Erection of a digital advertising sign on the Church Street Overpass, Hunters Hill

Development Application Assessment (DA 10082)

May 2021

Published by the NSW Department of Planning, Industry and Environment

Figure 5 | Digital sign location (Source: Amended Plans) (Source: basemap Google maps)

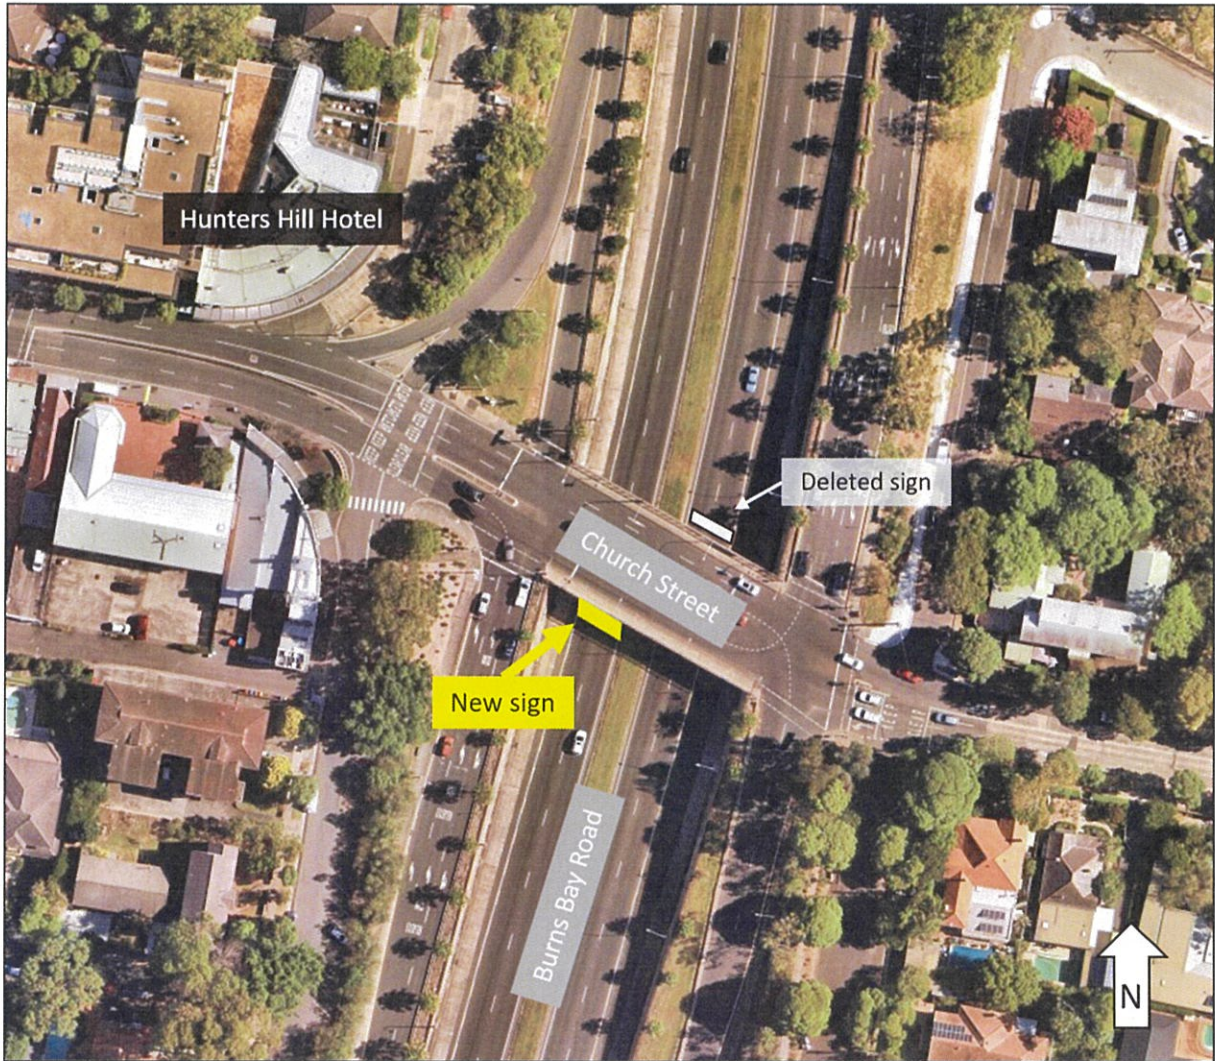
The Department notes the DA initially proposed two signs, on the north and south elevations of the Church Street overpass, however in response to concerns raised in submissions the Applicant has amended the proposal to delete the sign on the northern elevation of the overpass (**Figure 5**).
